City of Fremont
Newaygo County, Michigan
Wastewater Lagoon Improvements

PROJ #2023755002.00

ADDENDUM #1

DATE:07/31/23

SECTION 3
 SCALE: 1/4" = 1'-0"

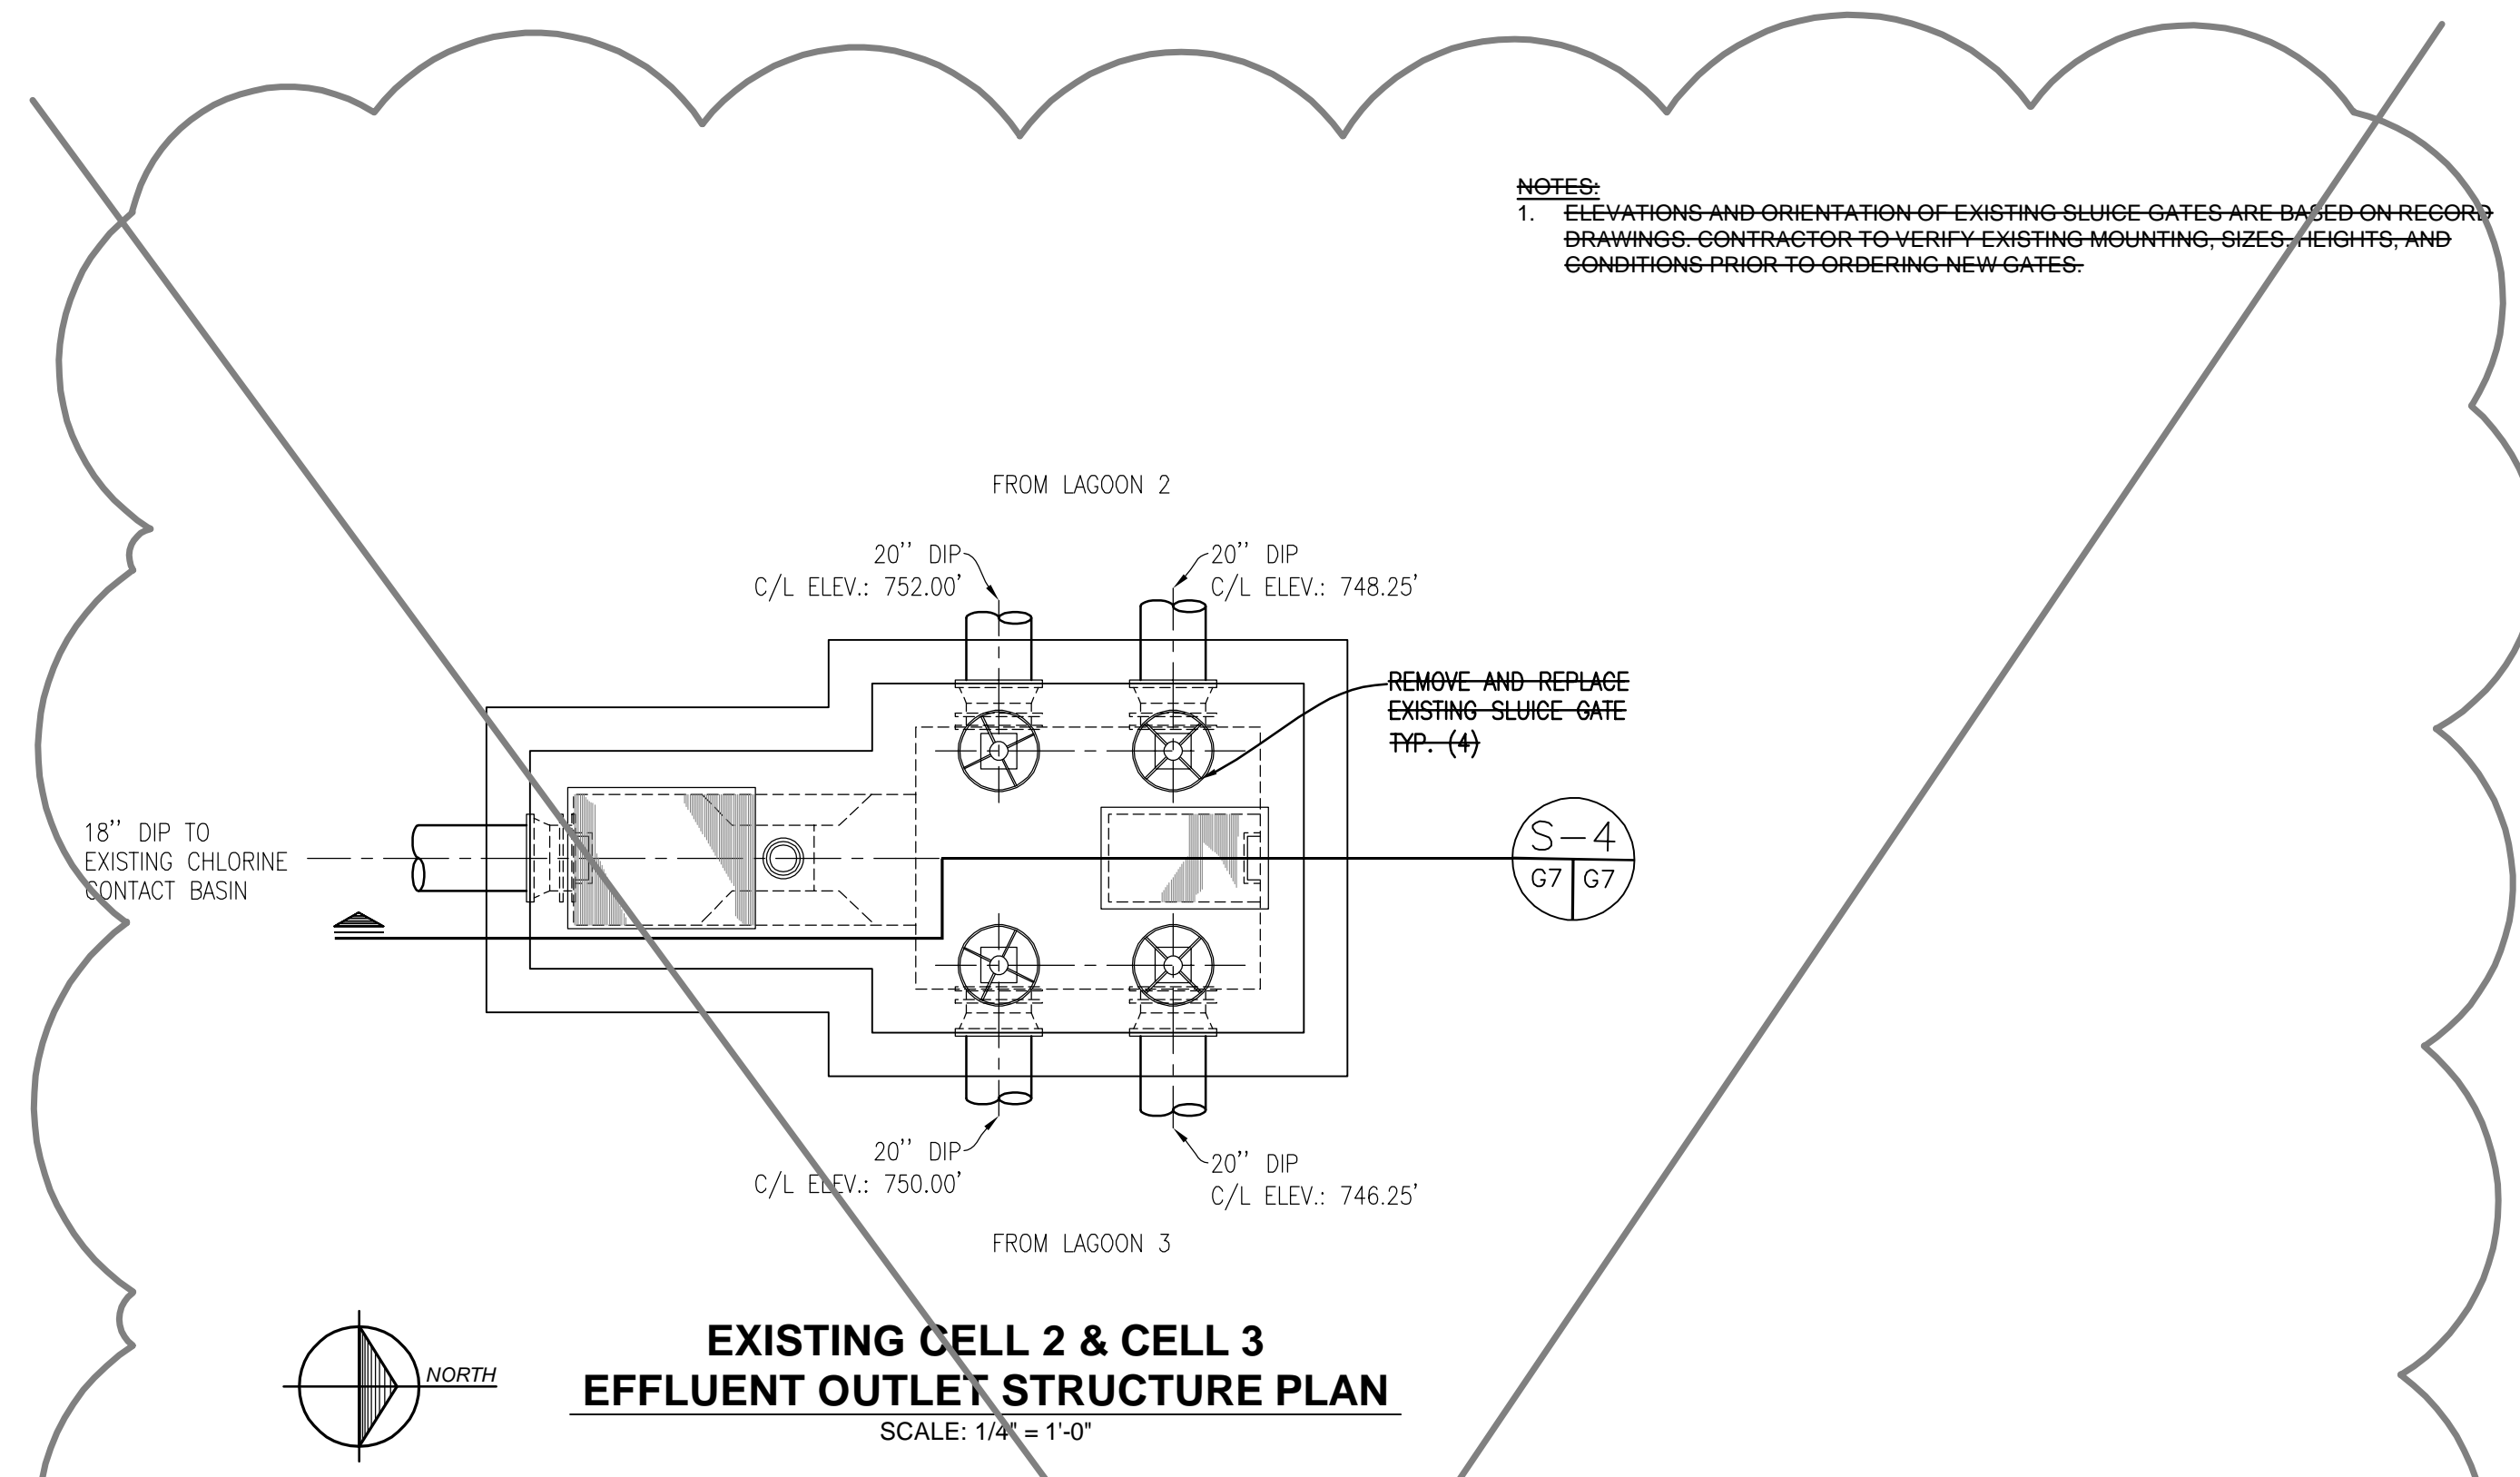
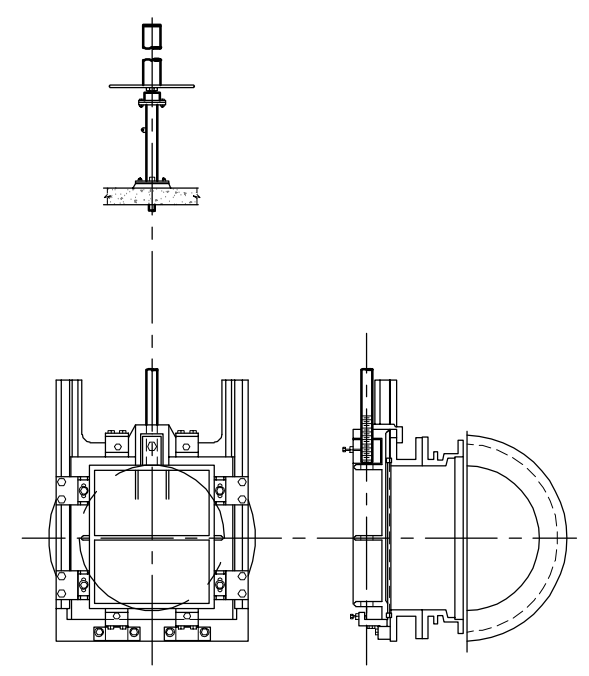
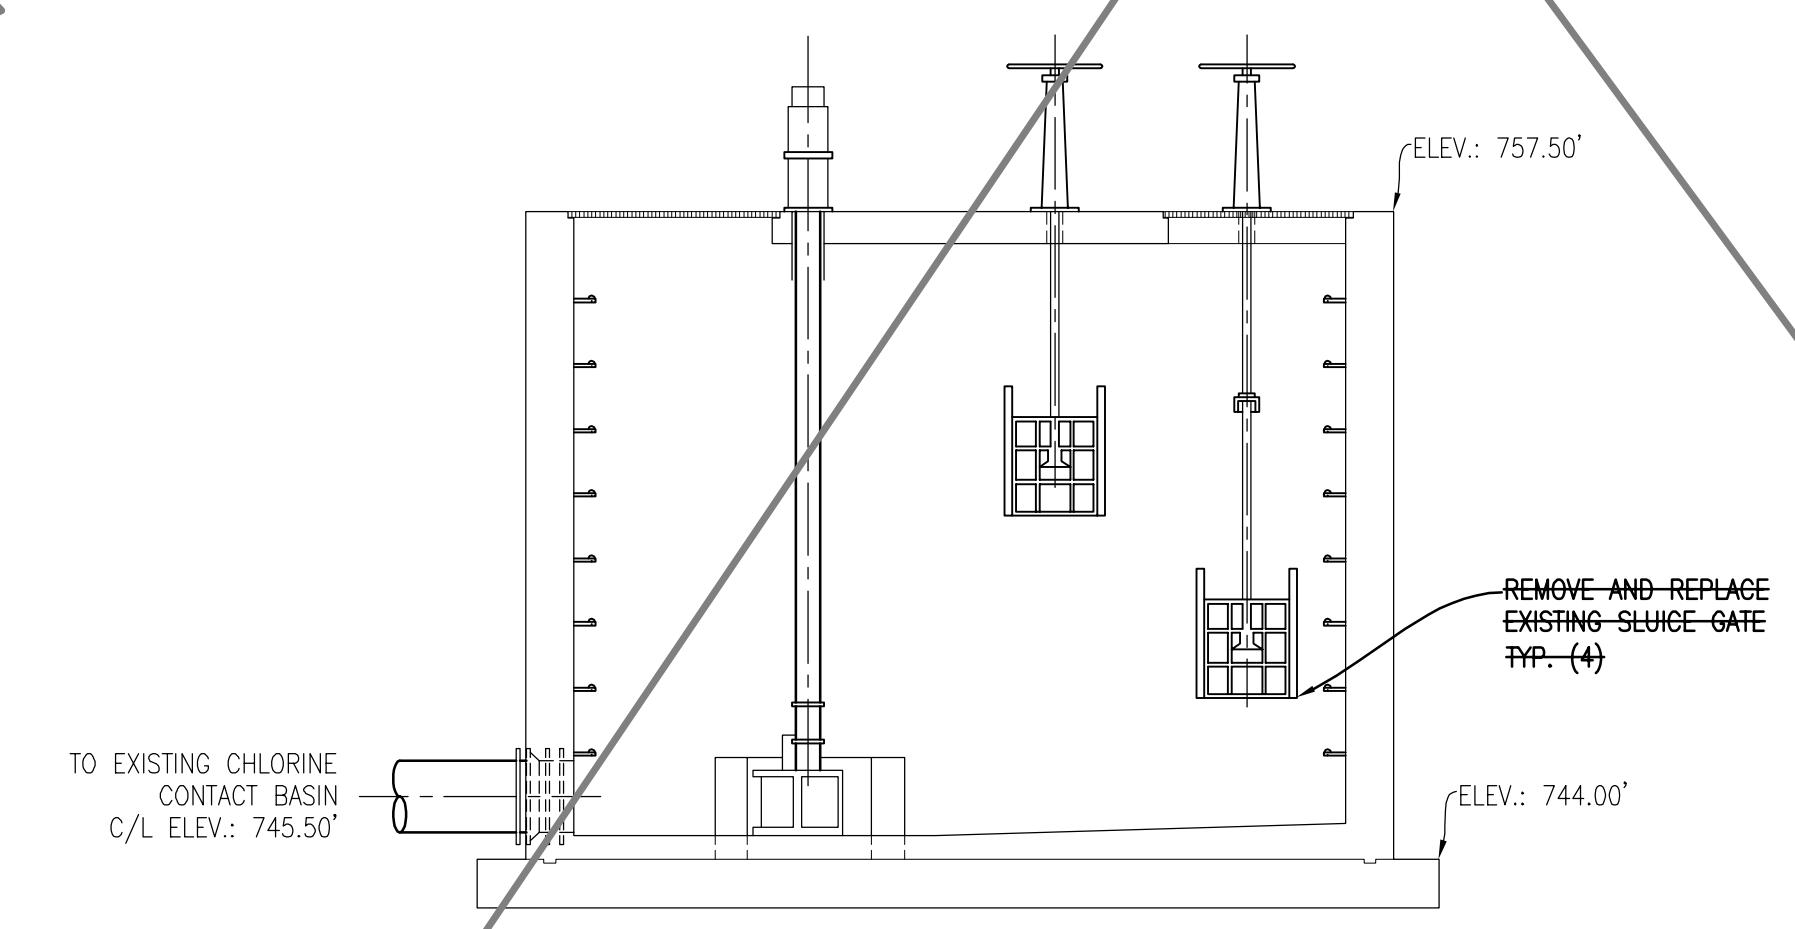
6. Sheet G7: Are any record drawings or manufacture/model# of existing sluice gates available for review?
Record drawings indicate the existing sluice gates are Armco Steel Corporation Model 55-20 with an 18” diameter.

1. **G5: REPLACE** with attached: Lagoon 4 By-passing piping valves to be gate valves with box, lid and telescopic extension stem.
2. **G7: REPLACE** with attached: Replacement of existing sluice gates has been eliminated from the project.
3. **G8: REPLACE** with attached: Irrigation Pump Station Plan: 10” **Ball Plug** Valves
4. **G10: REPLACE** with attached: Overflow pipe to be 20” CPP, Road Gravel to extend over anchor trench to top of basin stone anchor system, in addition to access road as shown on plans. Sand cover to be 12” with 6” stone.
